Zoning & Subdivision Committee  
Thursday, December 12, 2013 11:30 am

## Staff Report – Woodbine Section 2 Amended Preliminary Plat

Re: Woodbine Village – Amended Section 2 Preliminary Plat Review

Issue Dates:						
<b>Date:</b> 10/23/2013 <b>Scale:</b> AS NOTED						
<b>Drawn By:</b> DAS			<b>Checked By:</b> JDW			
<b>Project Number:</b> <b>12-0001-543</b>						
<b>Drawing Number:</b> <b>4 / 5</b>

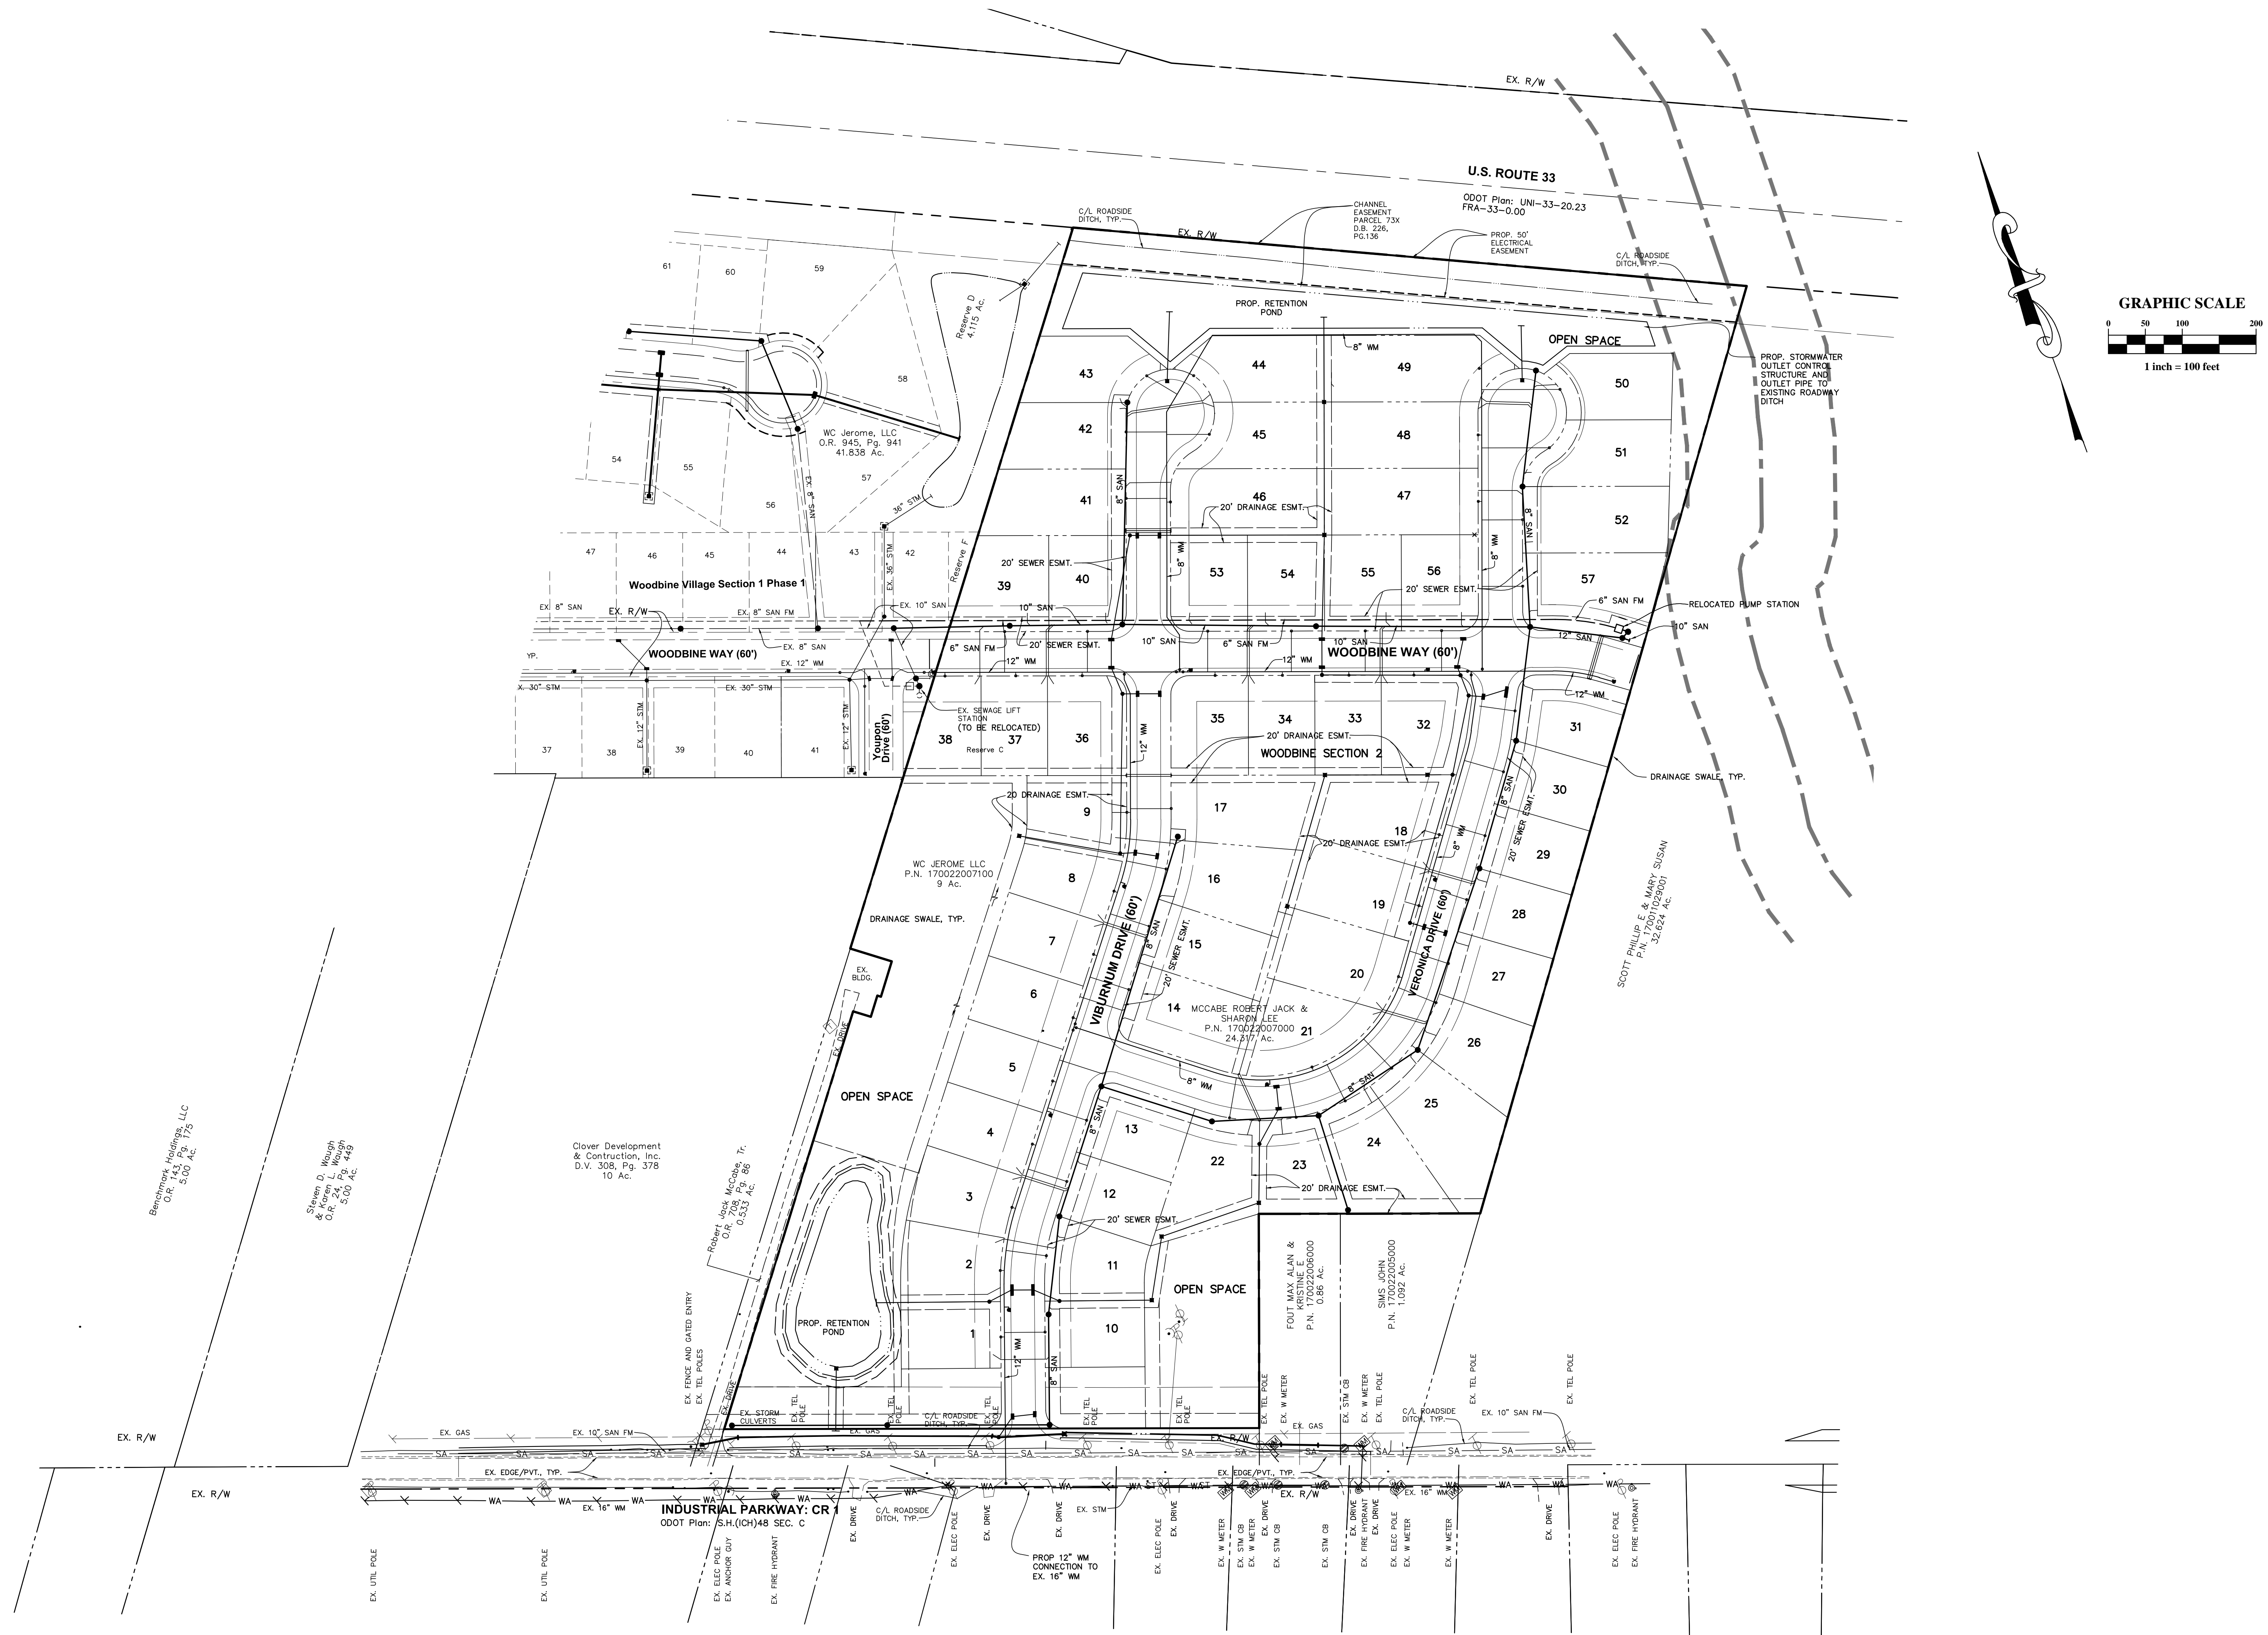
1. Show and label all easements, including width. Provide indication of where private utilities (phone/CATV/electric) will reside, and provide easements for these utilities. Easements will be required around all stormwater detention facilities, for access and maintenance.

5. GIS topography behind lots 27-57 do not indicate a swale as shown in the drawings. Please verify this topography during final design. If a drainage swale is present and is intended to remain and convey runoff, a drainage easement will be required in this area.

- 1) Drawing 4/5 shows easements labeled as sanitary, drainage and sewer (storm?).
- 2) Also indicated on the drawing are the water and sanitary mains
- 3) There is no notation or provisions for a electric/phone/CATV easements

- 6) In many cases the water, sanitary or storm easements are large (20') and exclusive.
- 7) URE and the phone/CATV utilities are often overlooked when the preliminary and final designs are done.

- 9) Sharing an easement is not a problem in most cases with URE – but if this is going to happen it should be identified in the preliminary plat and not after the fact.

- 10) Shared easements should be identified for all parties going in these spaces. Developers need to be aware of the URE service options and choose one prior to platting all the utility easements.

INDUSTRIAL PARKWAY  
TYPICAL WIDENING SECTION  
NO SCALE

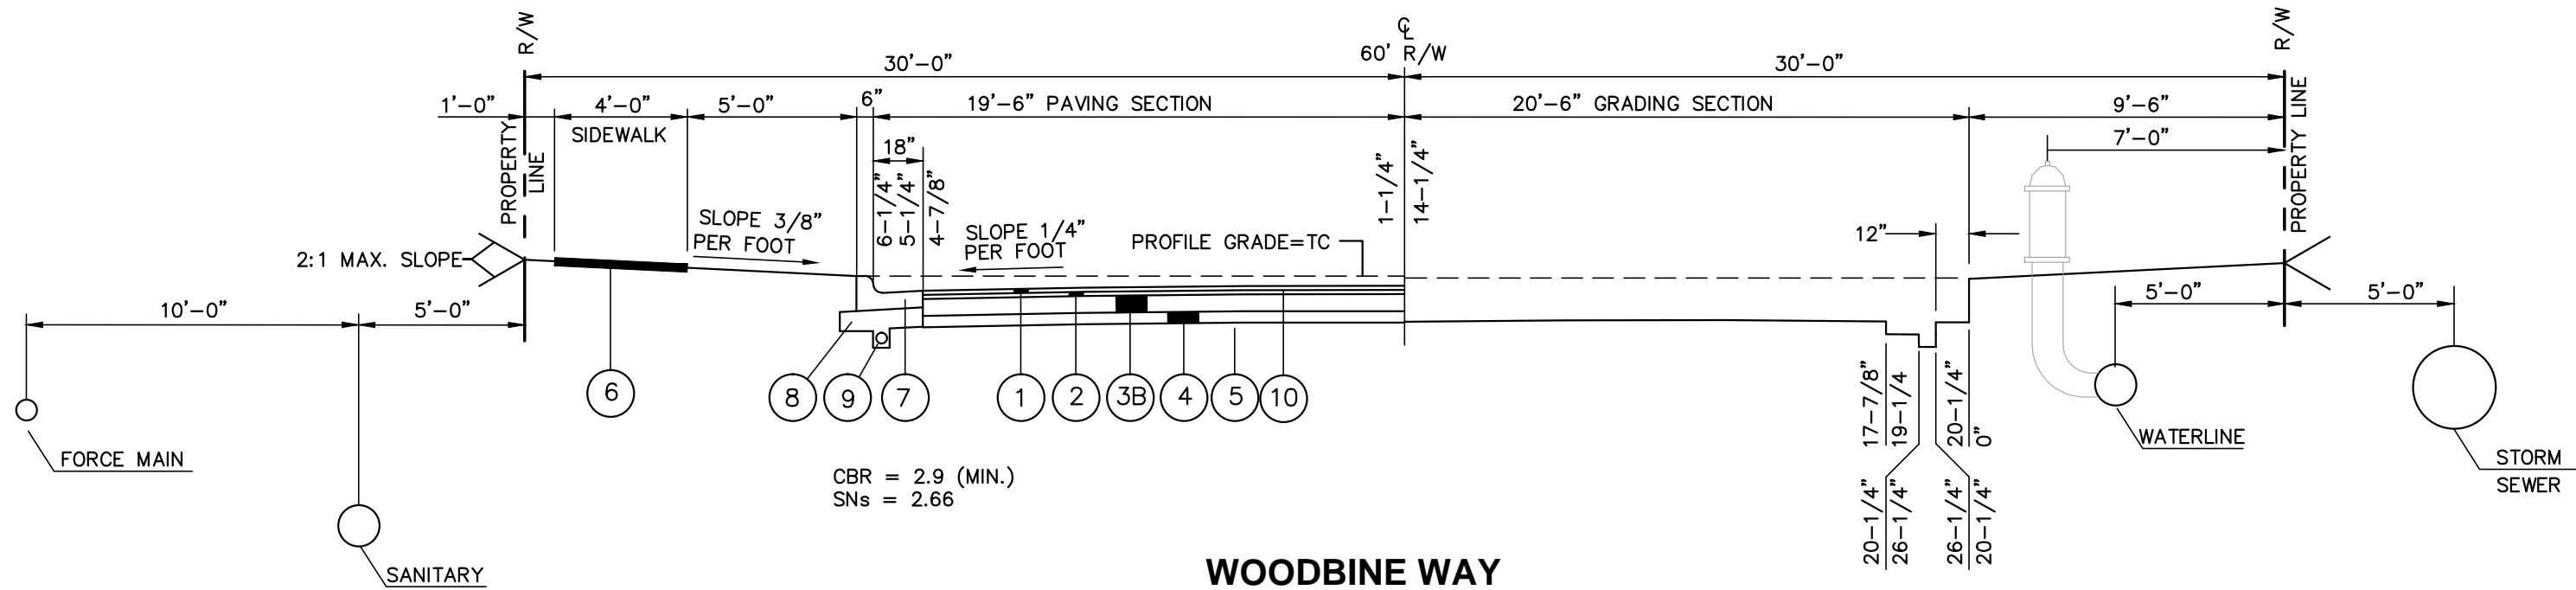
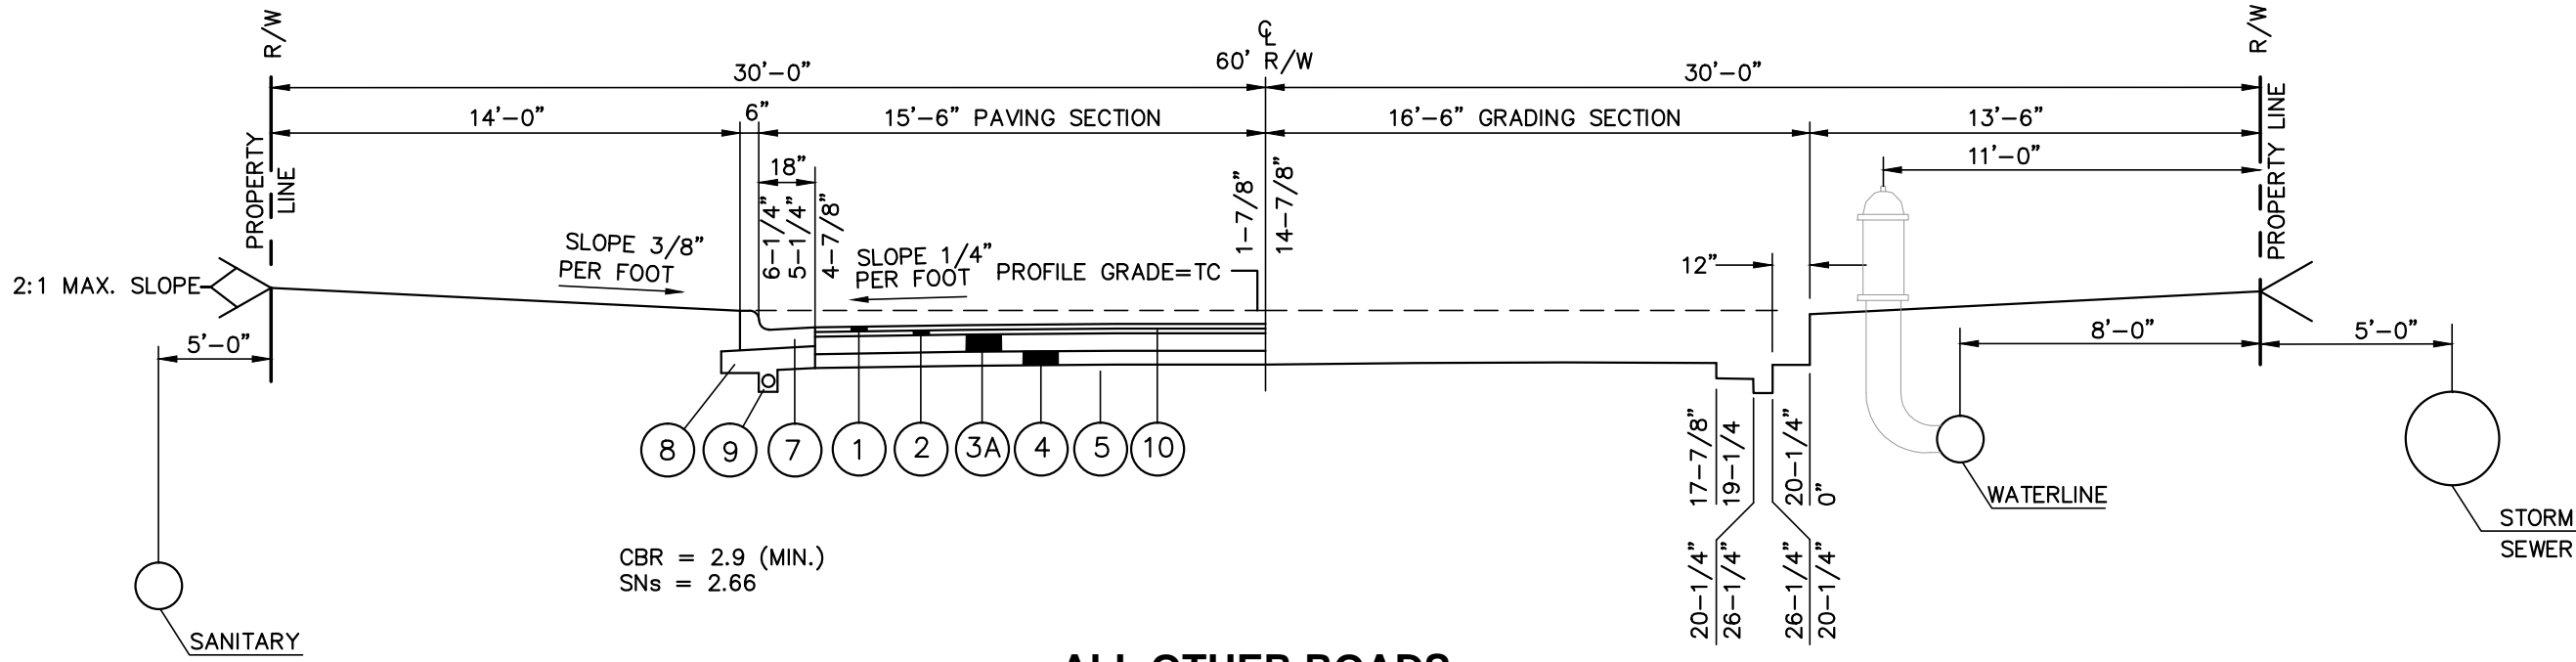
8. Our office will require the Industrial Parkway roadway improvements to be submitted as part of the subdivision construction drawings.
9. The following revisions are required to the typical section for the Industrial Parkway widening:

- a. Modify the pavement composition for the widening section to the following:
    - i. 1-1/2" 448 Surface Course
    - ii. 1-3/4" 448 Intermediate Course

- iii. 11-1/2" 301 Bituminous Aggregate Base
    - iv. 6" 304 Aggregate Base
    - v. Increase the berm to 4' in addition to the 4' shoulder
    - vi. Item 409 seal coat no longer exists. Revise the berm to be treated under ODOT 422.

- b. The entire width of Industrial Parkway shall be milled 1 1/2" to allow for the final surface course to be placed over the entire widening section.
